JAFP-22-0032
June 16, 2022

James A. FitzPatrick Nuclear Power Plant
Renewed Facility Operating License No. DPR-59
NRC Docket No. 50-333

Subject: Response to Request for Additional Information for James A. FitzPatrick Nuclear Power Plant to Adopt Risk Informed Completion Times TSTF-505, Revision 2, "Provide Risk-Informed Extended Completion Times - RITSTF Initiative 4b." and 10 CFR 50.69, "Risk-Informed categorization and treatment of structures, systems and components for nuclear power reactors."

Response to Request for Additional Information

Figure APLA-RAI-2-1 Reactor Building to Torus Vacuum Breakers (FM-18B, Rev 045)

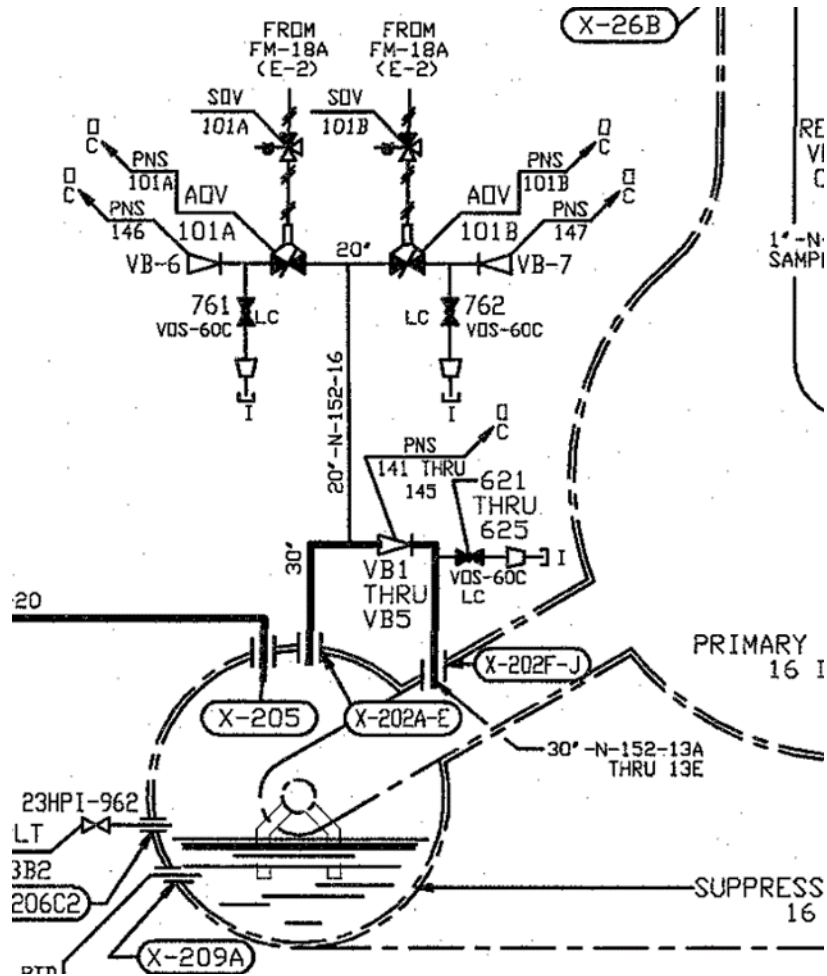
b. For TS 3.6.1.6.C in Attachment 6 of the license amendment request the licensee provides an implementation item to update the PRA models to include SSCs prior to exercising the RICT program for this TS.

- 1. Identify and describe what SSCs are presently modeled in the PRA, and the surrogate if applicable, used to assess the failure of the function for TS 3.6.1.6.C.*
- 2. Confirm that a RICT can be determined using the current PRA models consistent with the excerpt provided above from NEI 06-09-A and provide an estimate of the RICT for the TS LCO 3.6.1.6.C.*
- 3. Alternatively, remove TS LCO 3.6.1.6.C from the scope of the RICT program.*

The Fail to Open Function of the Torus to Reactor Building vacuum breakers has been added to an Application Specific PRA model (Ref. APLA-RAI-2-1) and this modeling is representative of what will be used in the configuration risk management tool. This Application Specific Model (ASM) was developed from the existing model of record (MOR).

The Vacuum breakers are also designed to open to prevent dangerously low containment pressure. The Failure to Open on Demand function had not been previously included in the MOR so it has been explicitly added to the ASM. The Open on Demand function of the Reactor Building to Torus Vacuum Breakers is designed to respond to negative primary containment pressure and equilibrate pressure to avoid containment implosion. Such conditions could occur following a LOCA in the drywell followed by prolonged operation of Drywell Spray. Prolonged operation of Drywell Spray could reduce pressure below atmospheric if the 2.7 psig trip of Containment Spray fails AND operators fail to manually control Drywell Spray per step D.4.14 of OP-13B (Reference APLA-RAI-2-2).

Vacuum breaker isolation valves 27AOV-101A and 27AOV-101B must open to allow vacuum relief and remain closed to isolate primary containment. The normally closed, fail closed position of the vacuum breaker isolation valves, along with the vacuum breaker check valves (27VB-6 and 27VB-7) provide the protection for primary containment. Supplying the isolation valves with a safety-related pneumatic supply (N₂) through 27SOV-101A and 27SOV-101B provides the capability to maintain primary containment integrity for either high or low containment pressure. The power supplies for 27AOV101A, B; 27SOV101A, B are 71ACA2 and 71ACB2. These are ultimately supplied by EDG-backed buses 10500 and 10600, respectively.

Figure APLA-RAI-2-1 shows the configuration of the vacuum breakers. Figure APLA-RAI-2-2 shows the relevant portion of the Nitrogen system and Figure APLA-RAI-2-3 shows the relevant power supply circuits.
